Russell Gap Stream Mitigation Project Year 2 (2021) Monitoring Report FINAL

DMS Project ID No. 100003, DEQ Contract No. 6980

Subject: Response to DMS Comments for DRAFT MY2 Report
Russell Gap Mitigation Project, Alexander County
DMS Project # 100003, DEQ Contract #6980, Catawba River Basin

Figure 3 Overview
Current Conditions Plan View
Russell Gap Project

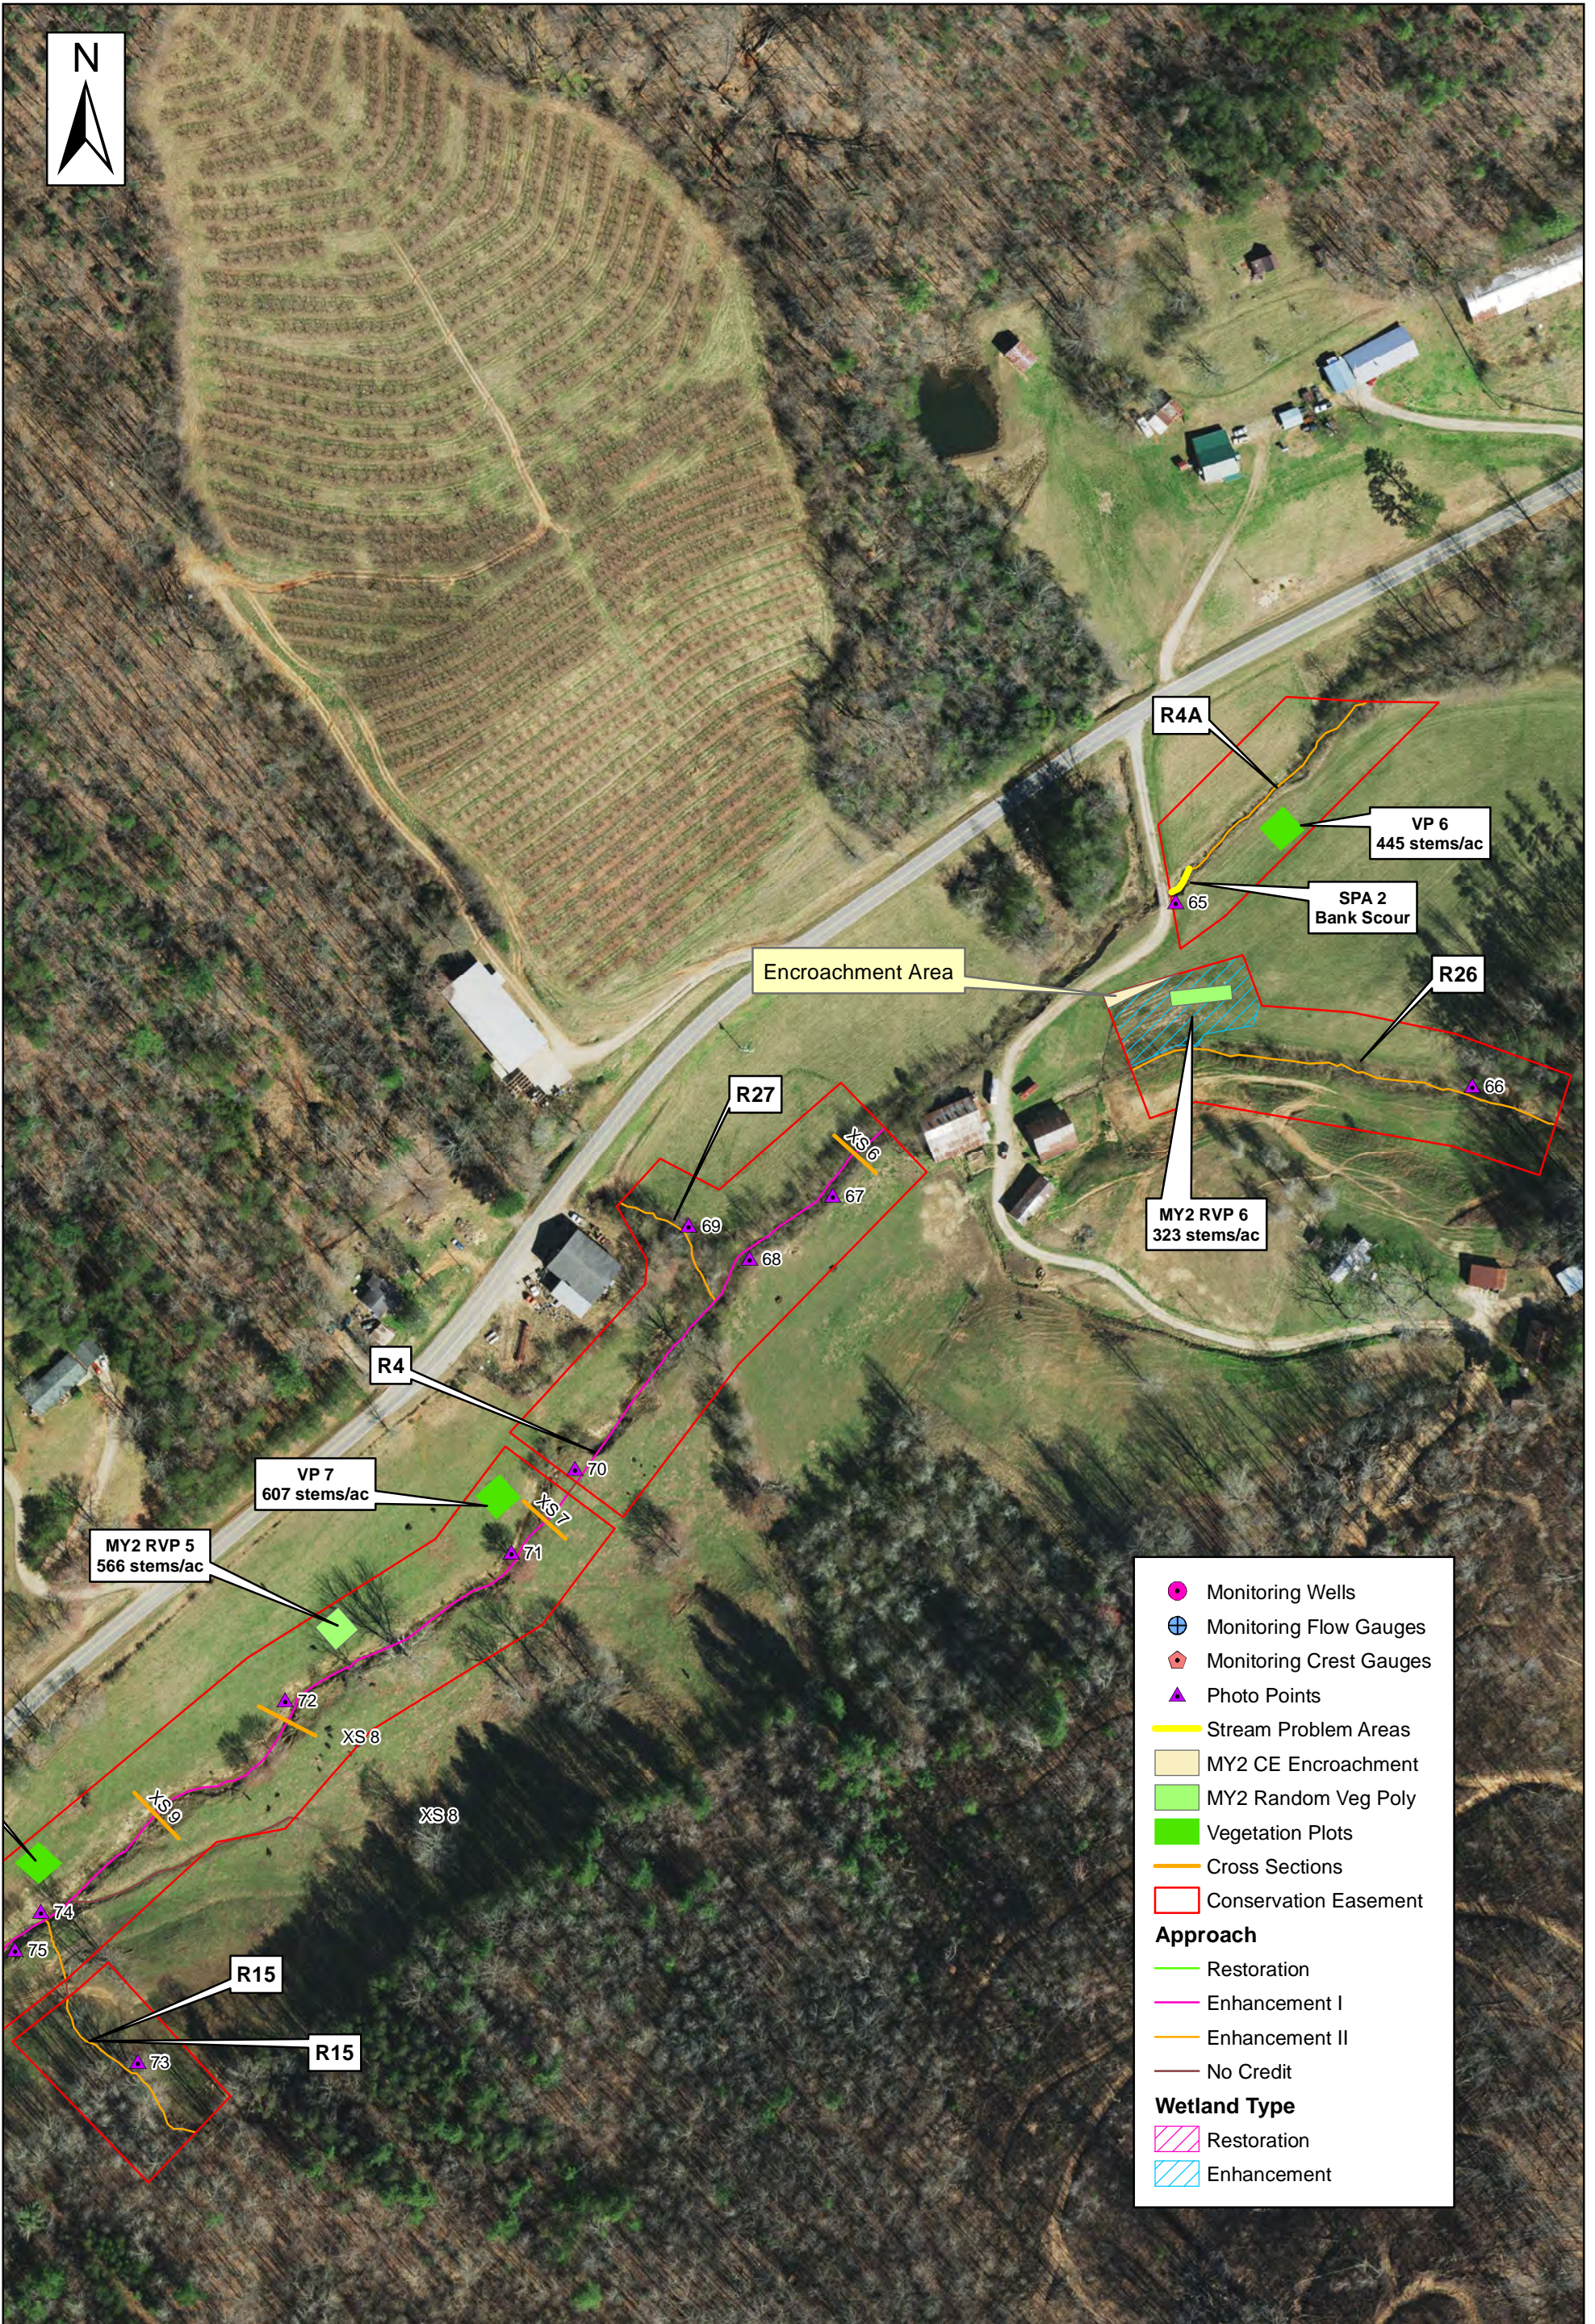
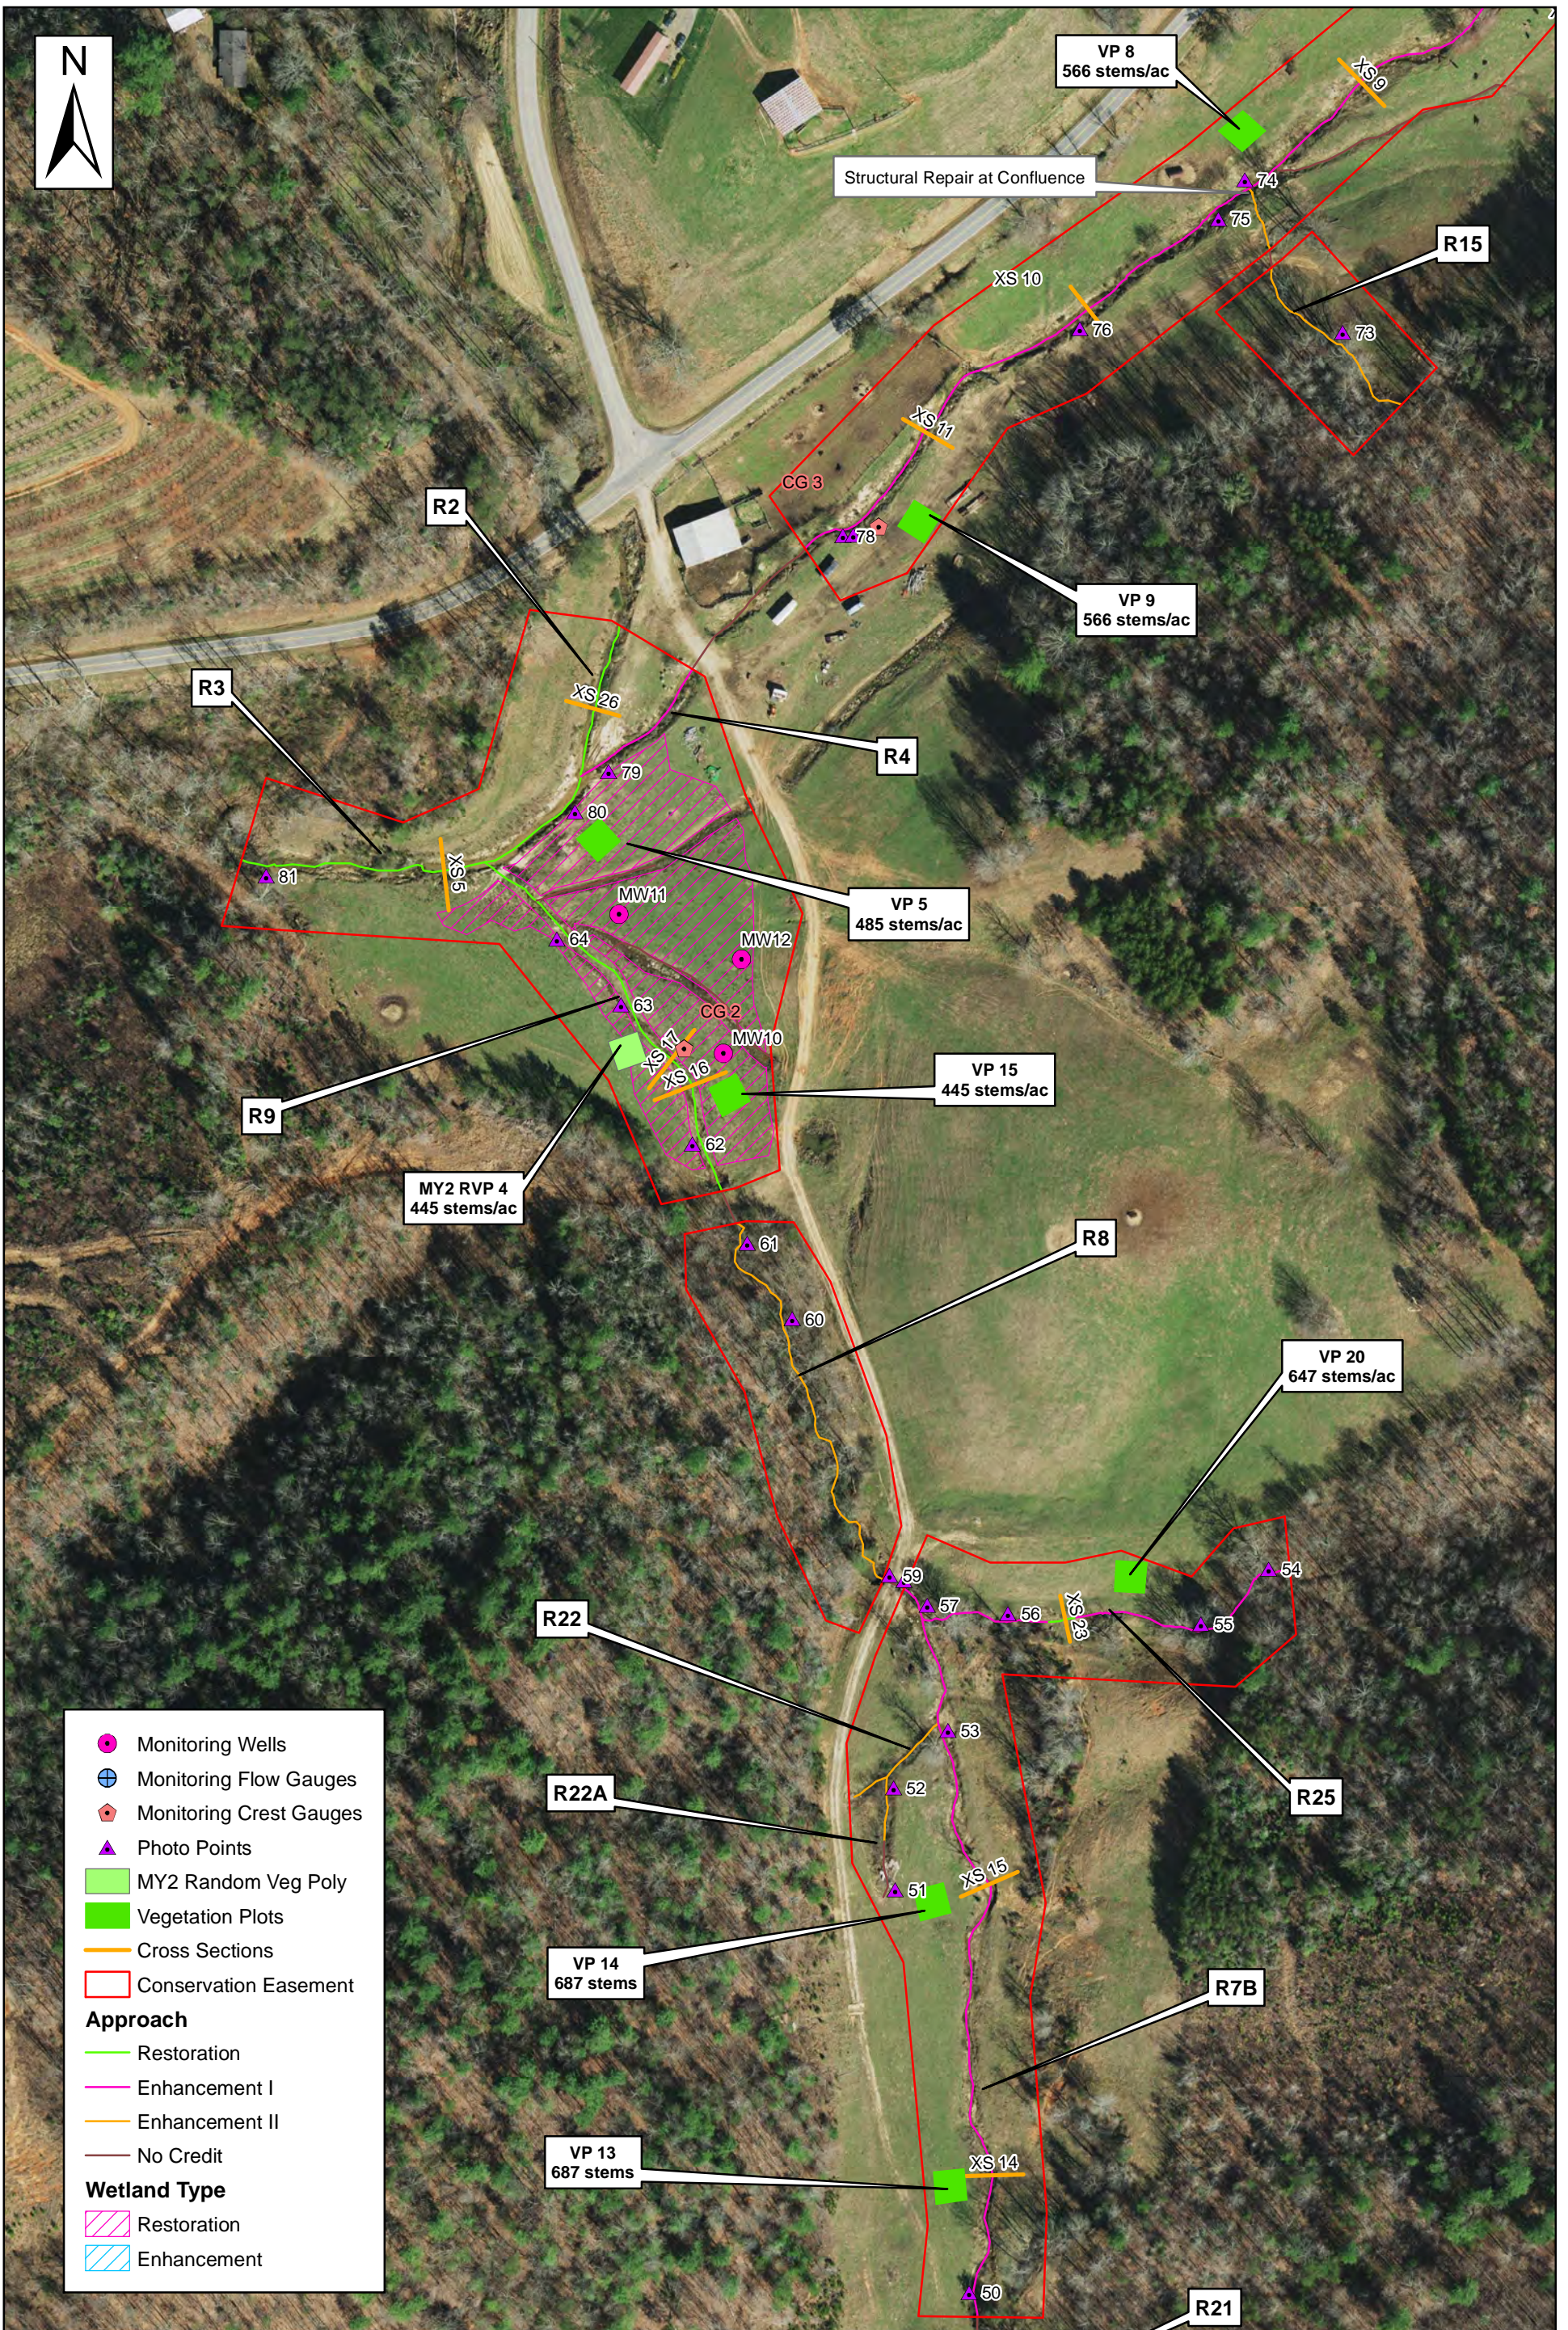
- Please include IRT meeting minutes from the June 23, 2021 site visit in the appendix.
Response: IRT meeting minutes have been included in Appendix F.
- Please include encroachment discussed in section 1.4 Monitoring Results on CCPV.

- CCPV: Include all areas that were repaired and replanted on CCPV.
Response: Repair areas have been added to the CCPV.
- Table 5 and 6: Please add dates to the tables to indicate when the field assessment was completed for the Stream Stability Assessment and Vegetation Assessment. The IRT has requested this information be included on these tables.

- Please include features representing the scoured eroding area along R1 and R4a and display these segments in the CCPV.
Response: These areas are shown as "Stream Problem Areas" on the CCPV and the shapefile has been included with the electronic deliverables.

Response: The encroachment area has been added to the CCPV as a shapefile.
- Section 1.4 states 64.4 inches of rainfall was observed for the project and the annual historic average is 56.1 inches. Figure 7 note states historic average annual rainfall is 52.51 inches while the observed project rainfall was 55.76 inches. Please review and revise as necessary.
